Department of Energy
Carlsbad Area Office
P. O. Box 3090
Carlsbad, New Mexico 88221
SEP 14 1995

40 CFR Part 194 Comments to be Submitted to the Environmental Protection Agency

**THE U.S. DEPARTMENT OF ENERGY'S
ADDITIONAL COMMENTS
ON
THE CRITERIA FOR THE CERTIFICATION AND DETERMINATION OF THE WASTE
ISOLATION PILOT PLANT'S COMPLIANCE WITH ENVIRONMENTAL STANDARDS
FOR THE MANAGEMENT AND DISPOSAL OF SPENT NUCLEAR FUEL, HIGH-
LEVEL AND TRANSURANIC RADIOACTIVE WASTES
40 CFR PART 194, PROPOSED**

Figure A-6. PWR throwaway cycle (case 1) - untreated dilution index (all sources).
 Source: US EPA, 1977, *Technical Support of Standards for High-Level Radioactive Waste Management, Volume A, Source Term Characterization*, Arthur D. Little, Inc., EPA 520/4-79-007A.

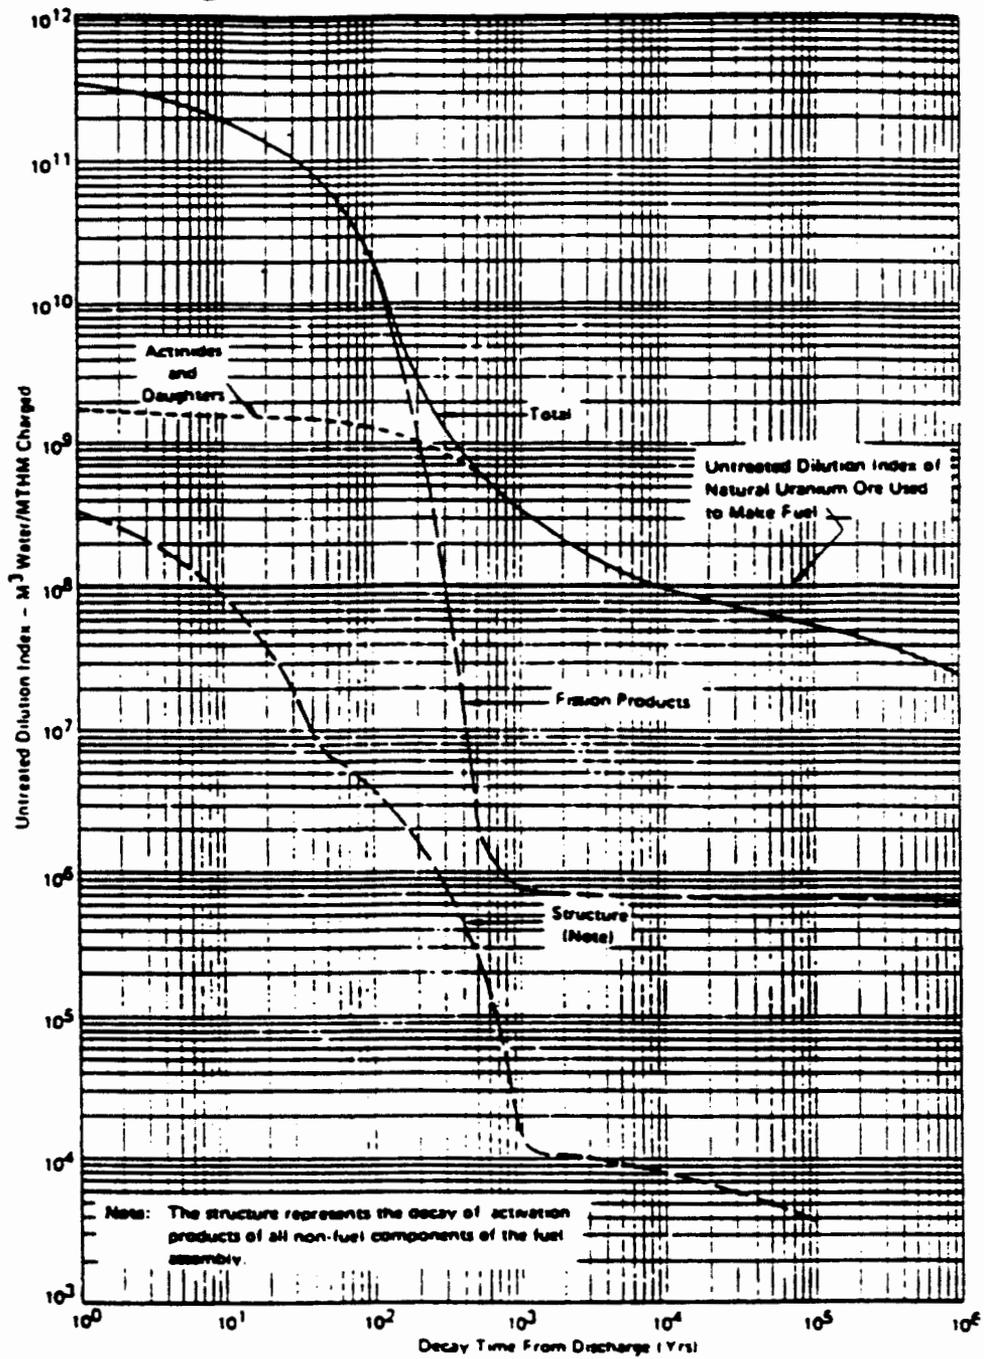
The decay time from discharge for fission products, actinides and daughters, and natural uranium ore for spent fuel from the PWR fuel cycle without reprocessing is shown on Figure A-6, from US EPA, 1977. Fission products clearly dominate for the first 200 years, and initially exceed the UDI of actinides by more than two orders of magnitude. Actinides decay to the UDI of natural ore in 10,000 years. More detail on the composition of the curves in

These curves show that release limits based on the health effects of HLW, as compared to the natural ore, significantly penalize a repository containing no HLW, such as a repository for TRU waste derived primarily from general process trash. The fact that ingrowth americium cannot be included in the calculation of the waste unit for a TRU repository (Pu^{241} has a half-life of 14y, while its daughter, Am^{241} has a half-life of 432 y), but must be accounted for in the release calculation, builds conservatism into the release limits. Similarly, uranium cannot be included in the waste unit, but must be accounted for in releases. Both are included in the waste unit for spent fuel or HLW repositories.

Figure A-7. PWR throwaway cycle (case 1) - untreated dilution index - fission products. Source: US EPA, 1977, *Technical Support of Standards for High-Level Radioactive Waste Management, Volume A, Source Term Characterization*, Arthur D. Little, Inc., EPA 520/4-79-007A.

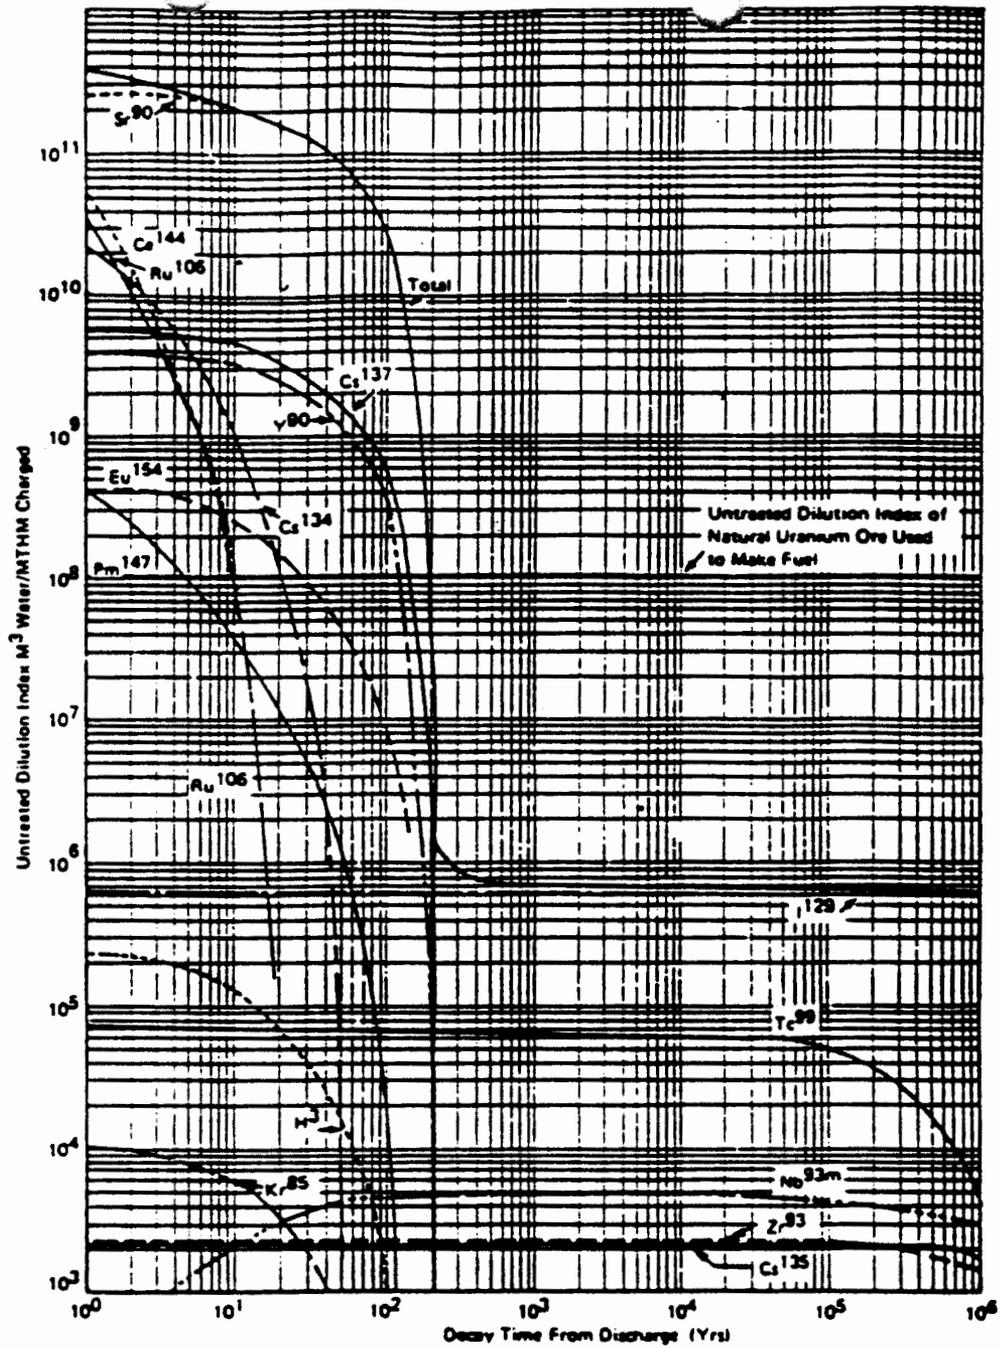
Figure A-6 is shown in the following two figures. The decay time from discharge for fission products and for natural uranium ore for the spent fuel from the PWR fuel cycle without reprocessing is shown on Figure A-7. After 10 years, Sr^{90} dominates, and decays to the UDI of natural ore in 200 years. The decay time from discharge for actinides and daughters and for natural uranium ore for the spent fuel from the PWR fuel cycle without reprocessing is shown on Figure A-8. Only three actinides ever exceed the UDI of the ore; these are curium, plutonium, and americium. Curium falls below the UDI of the ore after 20 years. Americium ingrowth (as a daughter product) raises its UDI above that of the natural ore during the first year, and it dominates the actinide activity from about the 30th year to the 2,000th year. Plutonium dominates for the first 30 years, exceeds the UDI of the ore by less than a factor of two after the 300th year, and falls below the UDI of the ore at about 4,000 years.

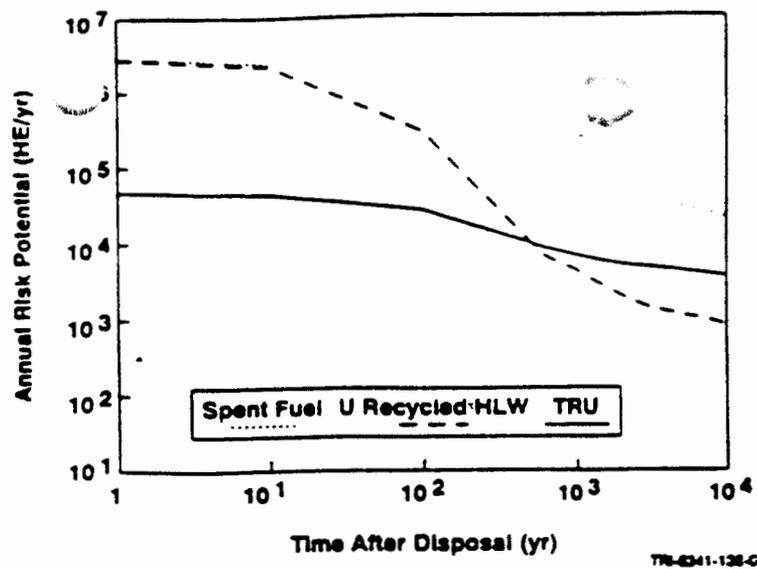
Klett (Klett, R. D., 1991, Proposed Extensions of United States Fundamental and Derived Standards for High-Level and Transuranic Radioactive Waste Disposal, SAND91-0211, Sandia National Laboratories, Albuquerque, New Mexico.) plotted the Annual Risk Potential in health effects/year versus time (see Figures 4 and 5 from Klett, 1991 which are attached). These plots demonstrate that the risk potential from TRU waste is consistently at least an

order of magnitude less than that for spent fuel, and that the time averaged risk potential is consistently less than that for either spent fuel or HLW. These plots also demonstrate that the existing release limits are more stringent for TRU waste repositories than for spent fuel or HLW repositories. Therefore, any additional conservatism in the calculation of the waste unit is inappropriate.
